South Texas Project Electric Generating Station P.O. Box 289 Wadsworth, Texas 77483

April 29, 2010  
U7-C-STP-NRC-100093

South Texas Project  
Units 3 and 4  
Docket Nos. 52-012 and 52-013  
Response to Request for Additional Information

Attachments 2 through 7 are revised or supplemental responses to NRC staff questions included in Request for Additional Information (RAI) letter numbers 289, 299 and 302 related to Combined License Application (COLA) Part 2, Tier 2, Sections 3.7 and 3.8. References 1, 2 and 3 provided the original response to the following RAI questions:

**Figure RAI 03.07.01-18a: Comparison of DCD SSE and Site-Specific SSE  
Seismic Soil Pressures for Reactor Building North Wall**

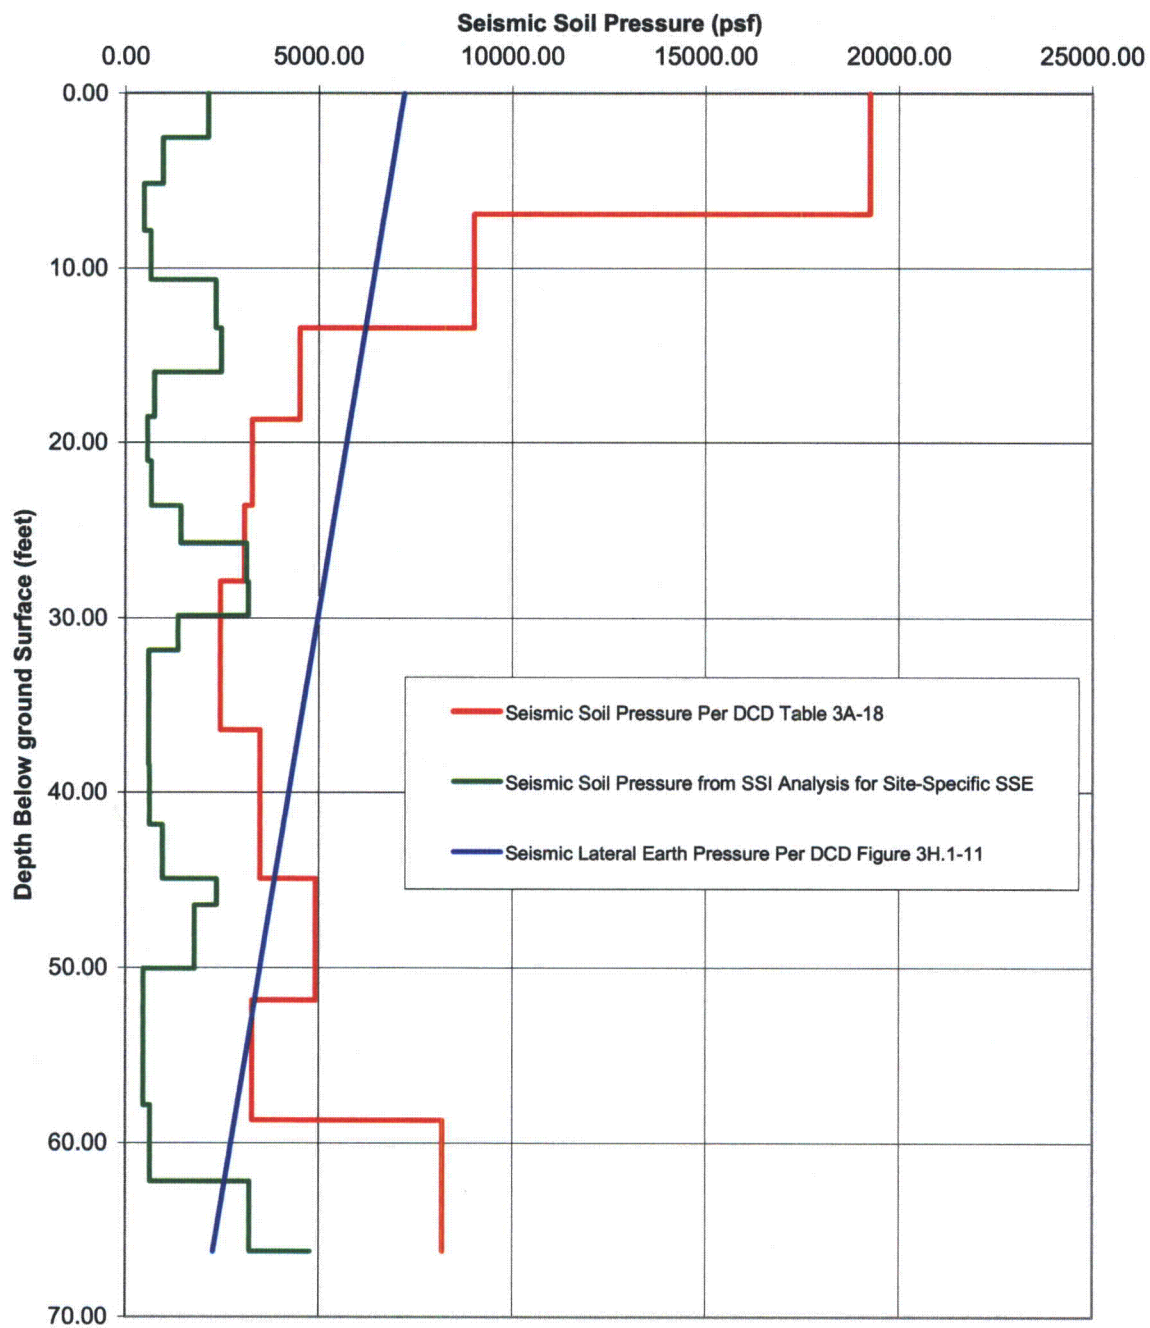
In the response to RAI 03.07.01-5, the applicant cited DCD Appendix 3A in concluding that “the potential effect of structure-to-structure interaction is relatively small.” However, DCD (see DCD Section 3A.9.7, Effect of Adjacent Buildings) also concluded that seismic soil pressure in between the RB and CB increased due to structure-to-structure interaction (SSSI) effect. The applicant is requested to provide soil pressure profile between the RB and CB, and discuss how the potential effects of the increase in the seismic soil pressure in between the RB and CB due to SSSI effect has been addressed and bounded by the certified design.

Attached Figures RAI 03.07.01-18a and RAI 03.07.01-18b provide the increased soil pressure profiles between the RB and CB due to structure-to-structure interaction for site-specific Safe Shutdown Earthquake (SSE) obtained from Soil-Structure Interaction (SSI) analysis along with the design soil pressures reported in DCD Table 3A-18 and Figures 3H.1-11 and 3H.2-14. As can be seen from these figures, the soil pressure profiles from the SSI analysis are bounded by the envelope of the certified design soil pressures from DCD Table 3A-18 and Figures 3H.1-11 and 3H.2-14 with one exception. The soil pressure from the SSI analysis for the CB slightly exceeds the certified design soil pressure at a depth of about 26 to 30 feet below the ground surface. At all other elevations the DCD soil pressures are higher (significantly higher at most elevations) than the site-specific soil pressure. Therefore, the total force due to the certified design soil pressure on the wall panel will be significantly higher than the total force due to soil pressure from the SSI analysis. Therefore, the design based on certified design soil pressures will be adequate for soil pressure profiles from the SSI analysis.
